CONTRACT CHANGE ORDER NO. 172
SHEET 3 OF 10

SAN FRANCISCO OAKLAND BAY BRIDGE
EAST SPAN SEISMIC SAFETY PROJECT
SELF-ANCHORED SUSPENSION BRIDGE
(SUPERSTRUCTURE & TOWER)

BIKEPATH DETAILS NO. 5

DETAIL C

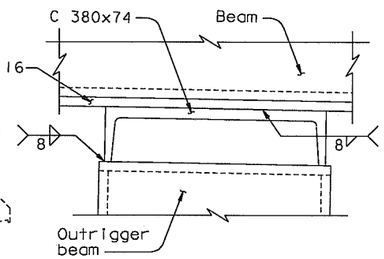
1. For Section A-A, see "Bikepath Details No.6" sheet.
2. For Section B-B and Detail C', see "Bikepath Details No.7" sheet.
3. Cantilever Truss 1, Truss 2 and outrigger beams to be installed by Others after demolition of existing structure.
4. The tolerance for placement of the anchor bolts is ±25 mm.
5. The Contractor shall survey the as-built anchor bolt locations and prepare a template. This template shall be trial fit in the field prior to drilling the holes in the angle.
6. The Contractor shall furnish all anchor bolt components and shall provide corrosion protection covering exposed ends.
7. Views of the deviation saddle are for illustration only. For deviation saddle details, see "West Deviation Saddle Details" sheets.
8. For Section F-F, see "Bikepath Details No. 4A" sheet.
9. At the Contractor's option, Detail C' may be used in lieu of Detail C.

DETAIL C (See Note 4)

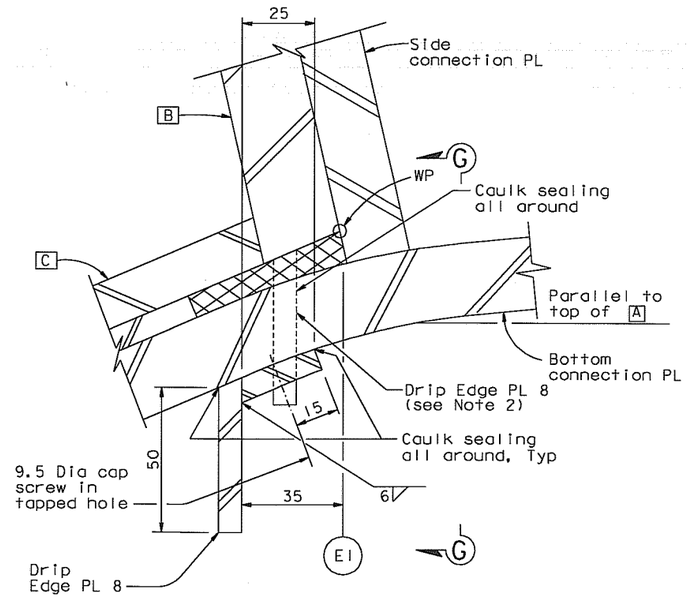
1. Round cope is provided for Contractor's fabrication and is optional. The cope shall be filled with caulk after drip edge PL installation.
2. Drip edge PL 8 welded to Girder Face C terminates at suspender bracket or bikepath cantilever beam where applicable. Caulk sealing shall be applied all around the termination. (See also Alternative Details on "Deck Drainage Details No.1B" sheet.
3. Section F'-F' is at location of bikepath support beam (E Line only).
4. Use detail at bikepath odd number panel points, from PP 9 to PP 111 and PP 117. For PP 113 and PP 115, see "Alternative Detail C" on "Deck Drainage Details No.1C" sheet.

ALTERNATIVE DETAIL C (WELDED OPTION)

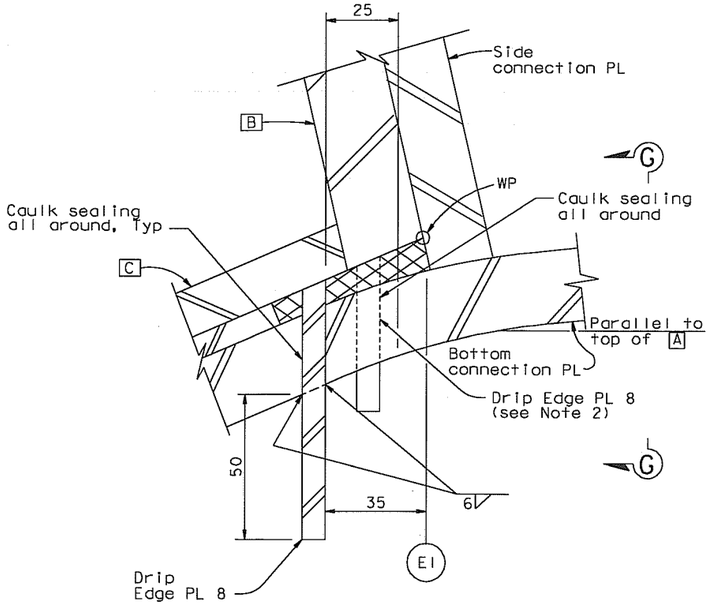
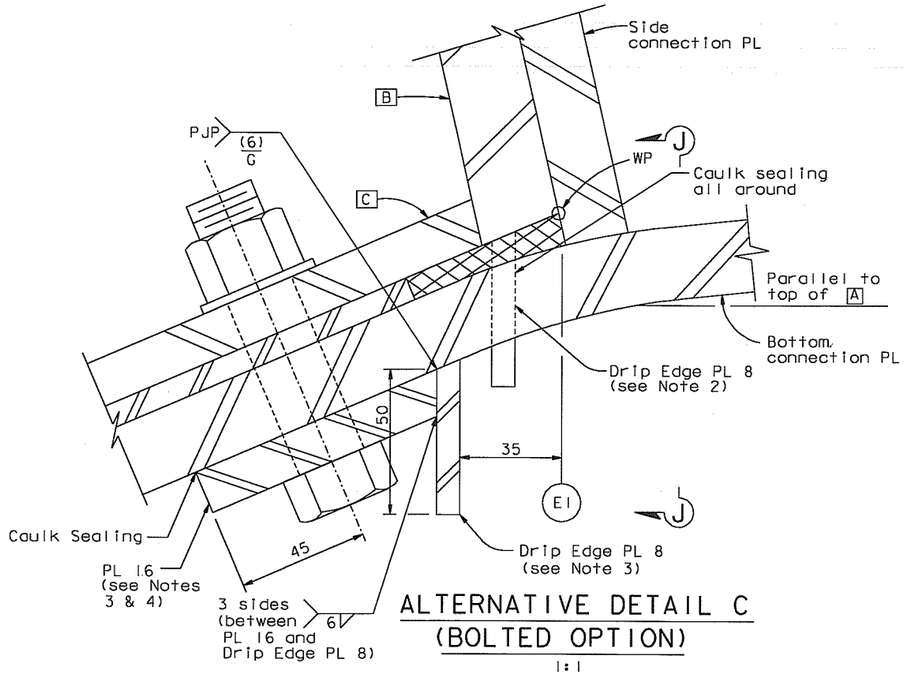
1. At the Contractor's option, "Alternative Detail C" may be used in lieu of "Detail C" on "Deck Drainage Details No.1A" sheet. For Bikepath PP 113 & PP 115, see "Alternative Detail C" on "Deck Drainage Details No.1C" sheet.
2. Drip edge PL 8 welded to Girder Face C terminates at suspender bracket or Bikepath cantilever beam where applicable. Caulk sealing shall be applied all around the termination.
3. PL 16 and drip edge PL 8 shall be pre-assembled prior to field installation.
4. At the Contractor's option, short-slotted holes or standard oversized holes are acceptable in Drip Edge PL 8, provided hardened washers are used.

ALTERNATIVE DETAIL C (BOLTED OPTION) (PP 113 & 115)

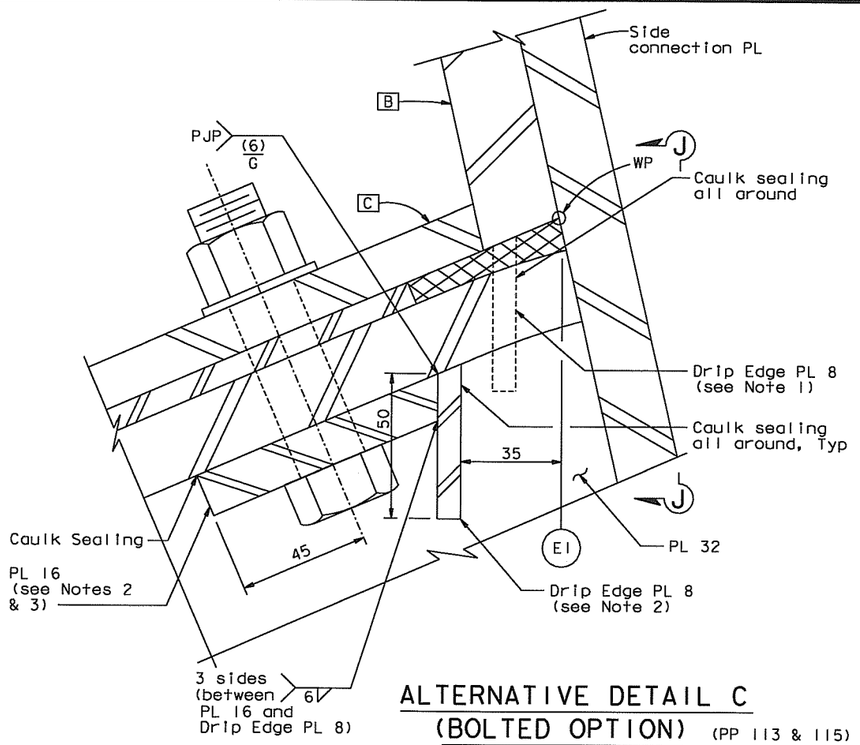
1. Drip Edge PL 8 welded to Girder Face C terminates at bikepath cantilever beam. Caulk sealing shall be applied all around the termination.
2. PL 16 and Drip Edge PL 8 shall be pre-assembled prior to field installation.
3. At the Contractor's option, short-slotted holes or standard oversized holes are acceptable in Drip Edge PL 8, provided hardened washers are used.
